Response to reviewer 2

The submitted paper focuses on a detailed comparison between large eddy simulations (LES) of the Lillgrund offshore wind farm and experimental LiDAR and SCADA data. Overall, I am impressed with the technical challenge the authors have approached. Further detailed comparisons between LES and real wind farm measurements are needed in the literature to further establish confidence in farm models, and to identify areas which require modeling improvements. The authors have provided the appropriate detail regarding their advanced LES solver and wind turbine representation, which includes turbine rotation and loads. Finally, the field data itself is comprehensive and compelling.

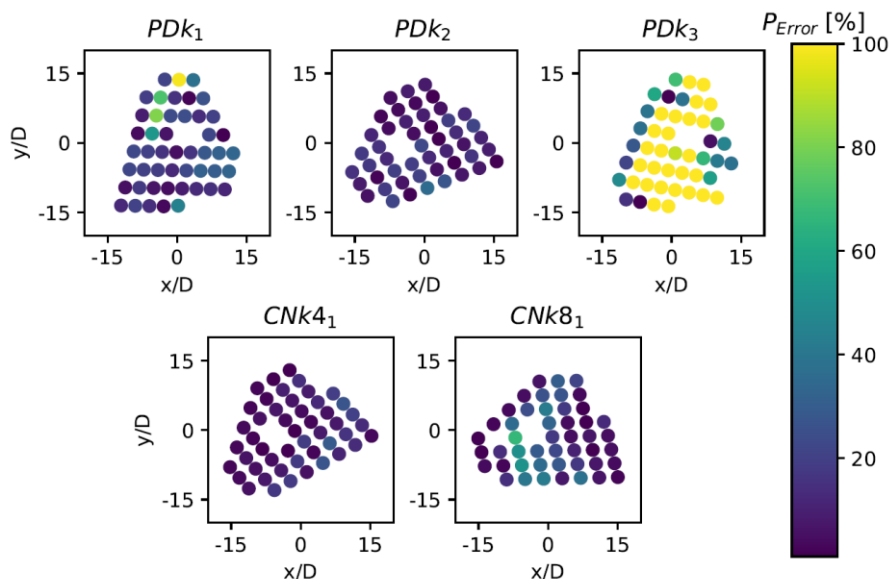
20. Section 4.2: Overall, I find this section and the outlined approach interesting. I recognize the technical challenges of what the authors are attempting, given fundamental inconsistencies between the CN or PD LES cases and the true ABL LiDAR measurements. Primarily, fitting neutral or PD ABL profiles to non-neutral ABLs may bias the results. So, I suggest the authors add an additional paragraph, addressing the following:

- a. Discussion of the stability during the LiDAR measurement time periods.
 - b. Discussion of how the optimization process which finds the minimum error compared to conventionally neutral or pressure driven boundary layers (with no stratification) may bias the considered cases.

- c. Given the poor agreement in the wind veer, discuss how the optimization process may have biased the results to over-emphasize wind speed compared to wind direction.

- d. Discussion of how the pronounced disagreement between LiDAR and LES above the rotor area may bias the vertical transport into the wind turbine array atmospheric boundary layer (WTABL).

We thank the reviewer for the suggestion and have now included an additional section 4.3 to acknowledge these shortcomings and sources of error. We agree that stability conditions at the Lillgrund site would have a significant effect on wind farm performance and the resulting errors in LES. However due to a lack of stability information during the measurement campaign, we were unable to include this in our methodology for recreating the inflow conditions. This has been summarized as below in section 4.3

“The developed optimization framework is therefore able to successfully recreate the inflow conditions at the Lillgrund wind farm for the chosen time periods, without significant errors in the mean inflow velocity across the rotor area, as evident by Figure 9. However, a few shortcomings of the optimization framework must be addressed. Atmospheric stability and stratification can play a significant role in the performance of a wind farm by affecting wake recovery and ambient turbulent intensity (Magnusson and Smedman, 1994). Additionally, due to the close land proximity of the Lillgrund wind farm, the atmospheric conditions at the farm can be significantly affected by a land–sea system as a combination of marine and land boundary layers. The current methodology does not take the meso-scale effects at the Lillgrund site into account, instead relying on a database comprising of marine pressure driven and neutral boundary layers to match the inflow conditions. This is due to the lack of atmospheric stability and temperature measurements at the Lillgrund site during the measurement campaign. If the data was available, the inflow database used could have been modified before the transformation procedure to consist of precursor boundary layers which best represent the stability conditions at the wind farm site. In its current form, the considered cases may be biased as they are chosen simply based on minimum error in the distance metrics and do not account for stability or land–sea effects. Additionally, without the inclusion of appropriate weights or additional distance metrics to penalize wind veer error, the current procedure may have been biased to overemphasize mean speed error as compared to wind veer error. The error in the LiDAR and LES velocity profiles above the rotor area could also affect the vertical transport into the wind turbine array atmospheric boundary layer (WTABL), which may affect the overall wind farm performance (Calaf et al., 2010).”

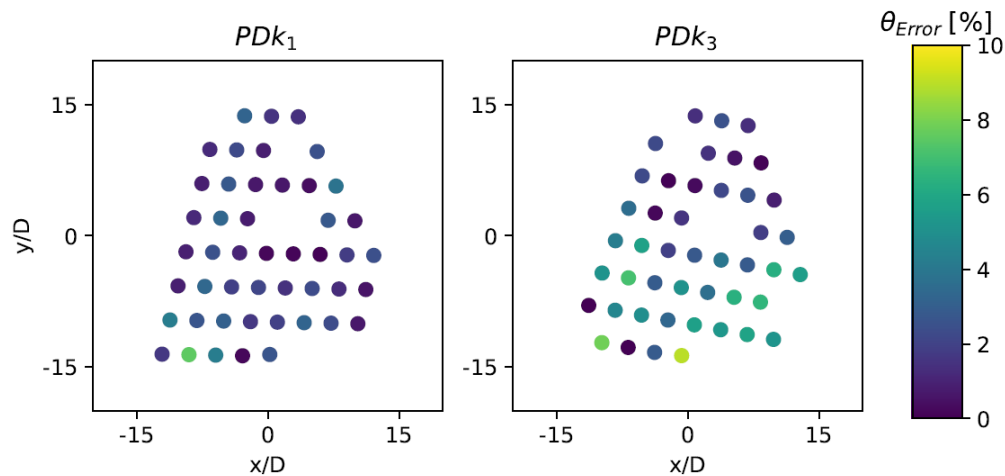
21. Line 286: “This is in accordance with the errors in the inflow profiles observed [...]” The analysis of the power results in this sentence appears weak and selective. First, putting aside the power and looking just at the wind profiles in Figure 8, all of the PD cases have high error in the wind veer, not just PDK3. Second, it is not clear from Figure 8 that the PD cases have lower wind speed error than the CN cases. For example, CNk8 seems to have fairly low wind speed and wind veer error. Cases PDK1 and PDK2 do not appear to have significantly lower wind speed error compared to the LiDAR than CNk8. The authors should revisit this analysis with more attention. I suggest quantitative metrics to support the statements.

We thank the author for this remark, and revisited the error analysis with more attention. Upon further investigation, we discovered that the main influence on the power errors observed are due to the wind direction and the waked/un-waked state of the wind turbine. From the below figure, it can be seen that the turbines operating right behind the first turbines exhibit the highest power errors, while turbines operating in un-waked or towards the back of the farm exhibit lower errors. This indicates a difference in wake recovery in LES and the field measurements which is further confirmed in the wake recover analysis. The errors could be due to a difference in stability, the high errors above the rotor in the developed inflow boundary layers, or differences in meso-scale effects which can cause wind direction changes across the farm as is evident from the newly added figure 16. The higher power errors for the PDK3 case can also be attributed to a difference in controller at the low wind speed regime, where the PDK3 turbines within the farm are exhibiting high pitch angles and operating in a start-up regime with negligible power production, which is not happening for our turbines in the simulation environment. We have now included the following figure and a new paragraph in section 5.3 to discuss this.

Figure 20. Comparison of far wake velocity wake deficit at downstream locations from turbine C06 for the case *CNk4₁*. Line at $y/D=0$ is perpendicular to the turbine orientation from SCADA data. Shaded area represents 95% confidence interval on the mean.

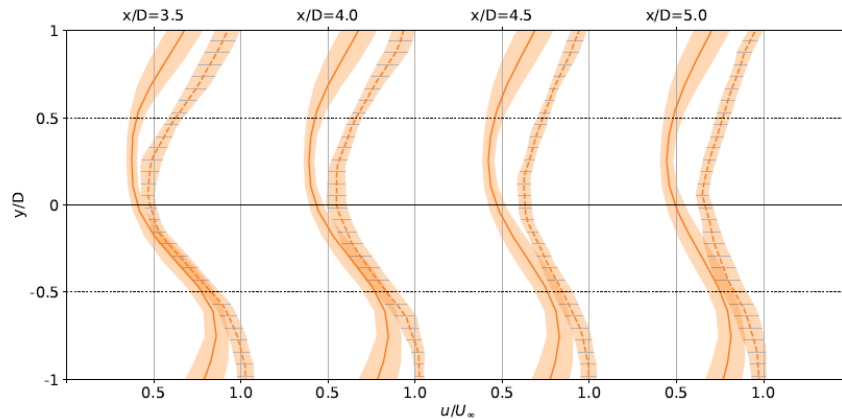
29. Figures 16 and 17: Why is the far wake comparison omitted from these plots? Please include. They are mentioned on line 335, so presumably the data is there. If they were selectively omitted due to poor agreement between LES and LiDAR, that is even more reason to include them in the figures.

A far wake analysis has now been included for the CNk4_1 case. This was not possible for the PDK_1 case as far wake lidar data was not available. The wake deficit figures have also been updated to include confidence intervals for the LES data.
